# **5TH & LENORA**

5TH & LENORA | PROJECT #3026266 1 RECOMMENDATION MEETING #2 07.10.2018

# **RECOMMENDATION MEETING #1 - SUMMARY**

# **OPTION 1 - CASCADE CONCEPT** (PREFERRED)

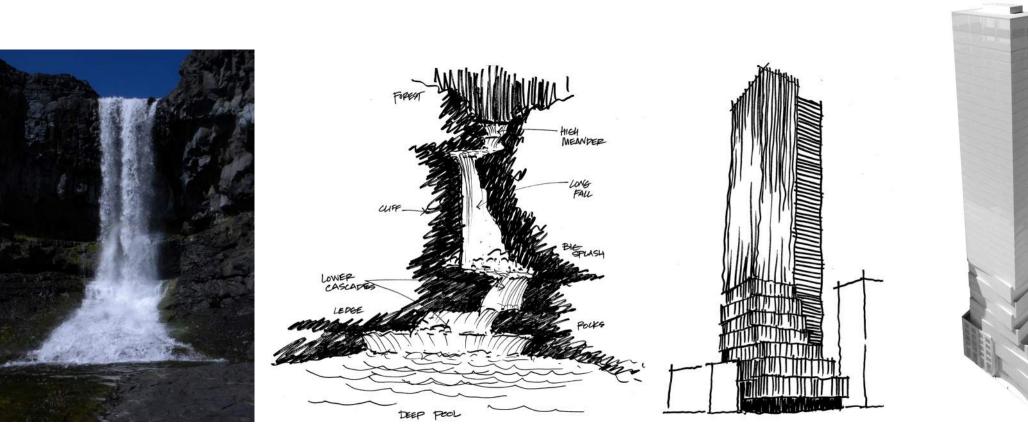
a. The majority of the members thought the concept needed more integration between the two tower forms as noted in the early design guidance, while two members were satisfied with design as shown. The design question on the table was the integration of the dark, straight tower and the sliding trays tower forms. The Board noted that the concept is logical and interesting with moving elements and static elements yet, the two-building concept is not yet resolved at its intersecting edges and areas for a pleasing combined tower composition. (A2, B1, B4-2)

In the original design (Option 1 as shown), the intersection of the two tower masses followed the concept of Cascade, with lighter, dynamic massing elements associated with a "waterfall" mass juxtaposed against and "falling across" a contrasting "cliff" mass as background for visual emphasis and support.

The Waterfall Mass is oriented toward the corner of Fifth and Lenora, where the tower has the strongest visual presence to the surrounding neighborhood, while the supporting Cliff Mass is oriented internally to the urban block and presents a visual support within the composition.

# PLANTER DIAGRAM

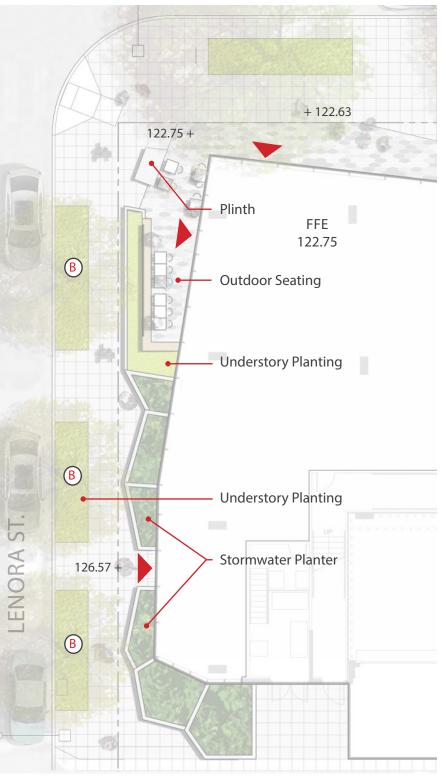
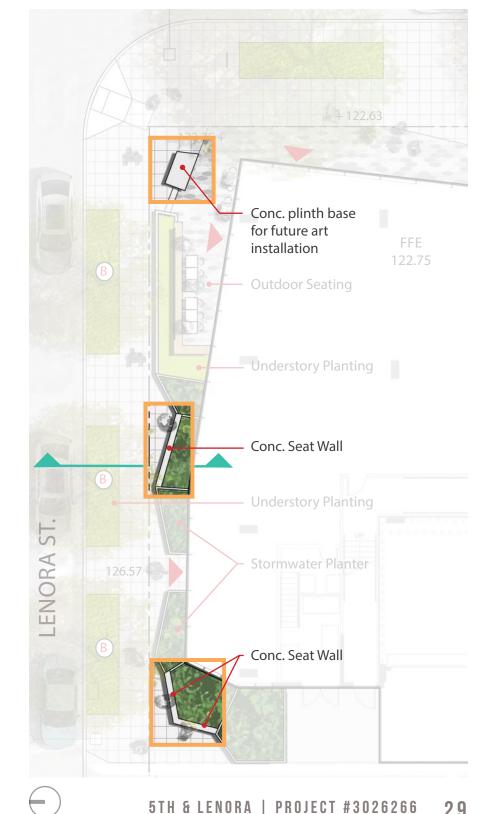
B. The Board supported the update to the Lenora Street outdoor retail seating configuration and directed the applicant to make the sidewalk facing walls of the bioretention planters appropriate width and height for seating. (B.3.3)

We have adjusted the planter wall heights and sizes to be more appropriate for seating.

The plan on the right shows the revised planter walls that integrate seating. The middle cell of each bioretention cluster has been widened to 12" to accommodate seating for the public, while still maintaining the required retention area. The middle cells also allow for the wall to be an appropriate height for seating.

Future Art Installation

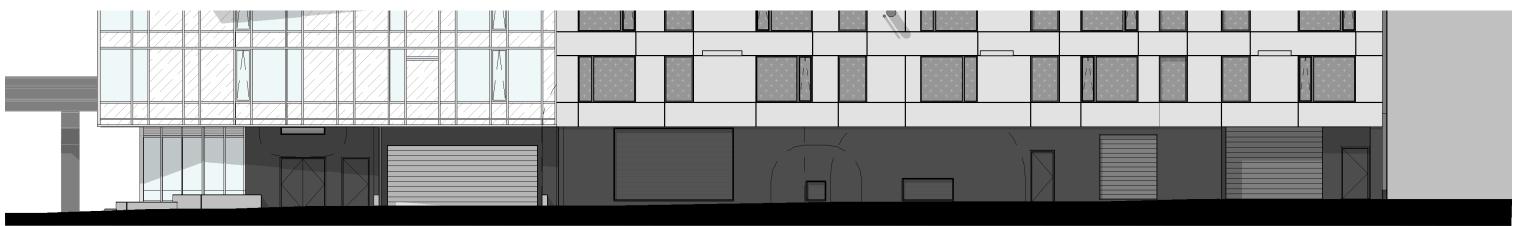
C. The board directed the applicant to develop the south [Norht] plinth to incorporate either seating, texture and/or art. (B3.3, B4.3)

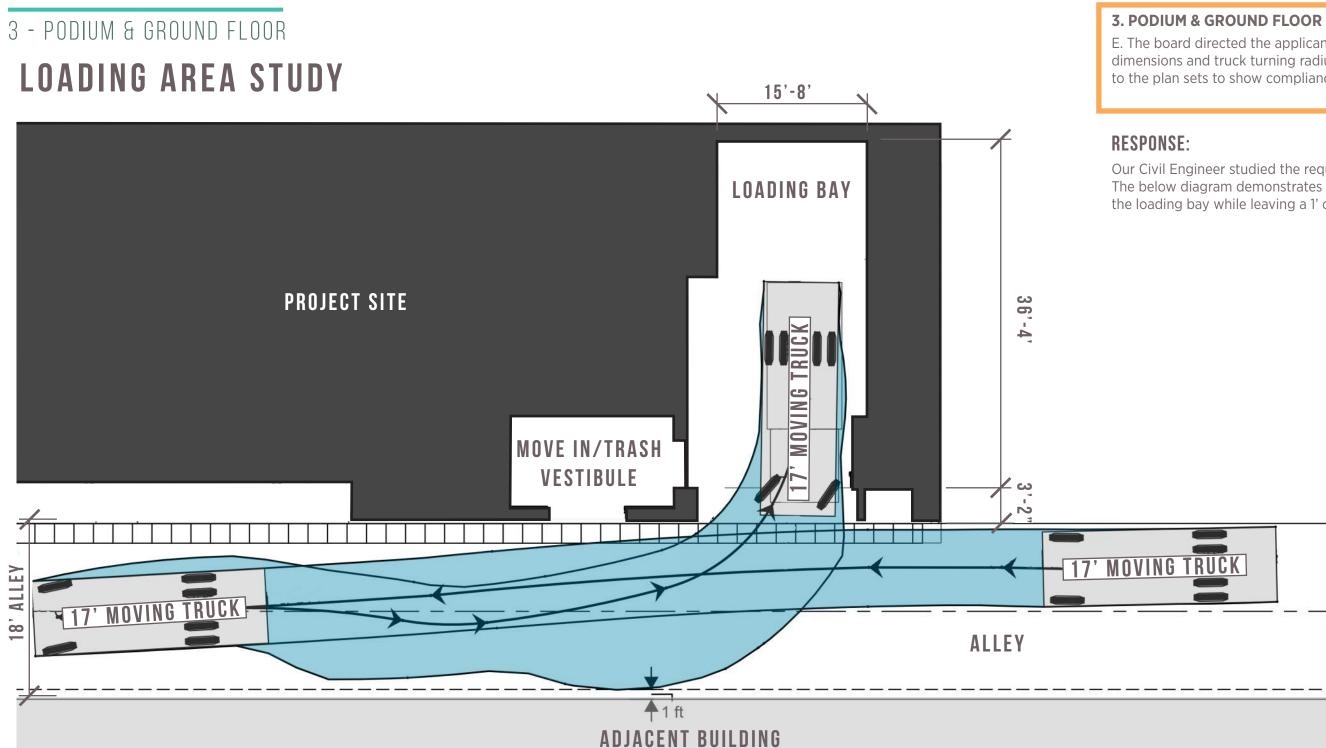
D. The board directed the applicant to add a joint pattern in the painted concrete alley wall that corresponds to the joint patterning in levels above for increased melding of the façade elements. The Board also recommended that a detail be provided to assure that no flashing is used at the edges of the trays so there is a crisp, clean edge that appears as an extension of the glazed tray elements. (B4.3)

**RESPONSE:** We have updated our design elevation drawings with this response to show joint patterns as requested.

# WINDOW WALL INTERSECTION DETAIL

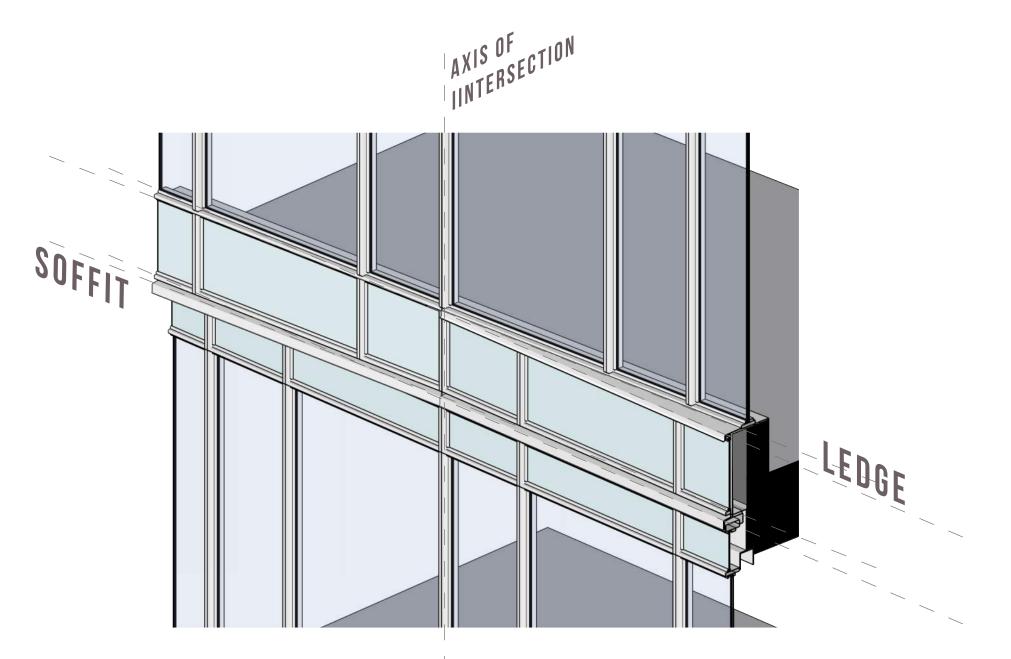
D. The board directed the applicant to add a joint pattern in the painted concrete alley wall that corresponds to the joint patterning in levels above for increased melding of the façade elements. The Board also recommended that a detail be provided to assure that no flashing is used at the edges of the trays so there is a crisp, clean edge that appears as an extension of the glazed tray elements. (B4.3)

Please refer to design details provided in our response to guidance item #2.b for proposed coping details at the tray step parapets.

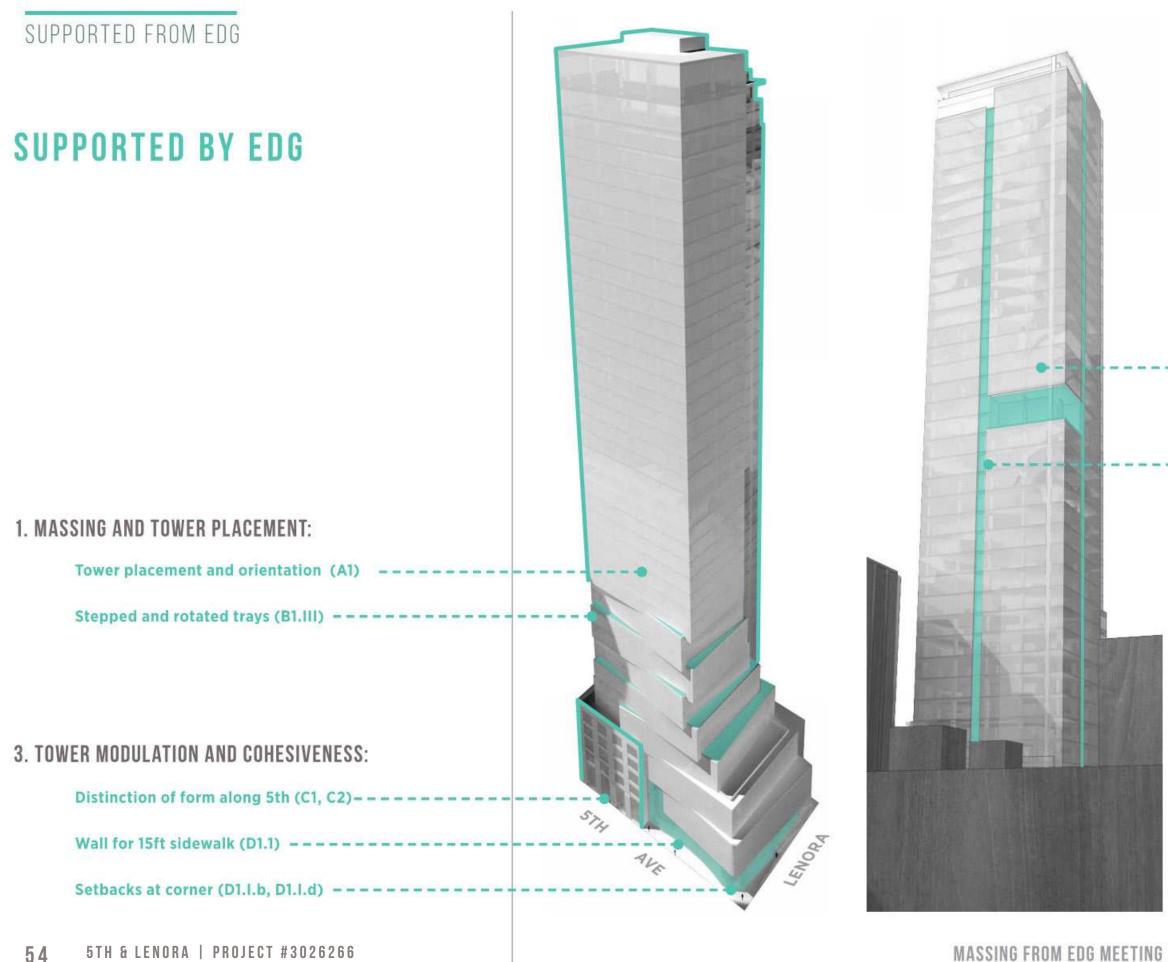
D. The Board supported a stepped, planter/rainwater element at the alley corner as shown on pg 63 and 70 (but ensuring good pedestrian sight lines), but agreed the planter along the Lenora storefront and the deep café moat [76/77] created a privatized zone and too many vertical pedestrian barriers between the sidewalk and the Lenora storefront. (D1-1.d, D1-I.b)

The Board recommended reducing or eliminating these elements to maintain a gently sloped sidewalk/setback near the corner (without guardrails or recesses), and sloping the sidewalk along a raised sill of storefront along Lenora. The Board supported shortening the planter portion adjacent to the street wall. Even if retail doors are near the corner, a 5 ft slope over the 106ft length of Lenora should not mandate a continuous privatized, buffer zone at this important storefront location. (A1-III; C1)

To increase pedestrian sight lines at the corner of 5th and Lenora, the team redesigned the storm water planters, reducing their height to be as low as possible and still meet storm water requirements.

The team maintained a cafe zone in response to item 3c, but redesigned the separation between the seating area and the side walk. The proposed design places a low planter between the seating area and the side walk address the change in elevation between. The proposed design also improves the permeability of the retail corner, reducing barriers for pedestrians moving through the space.
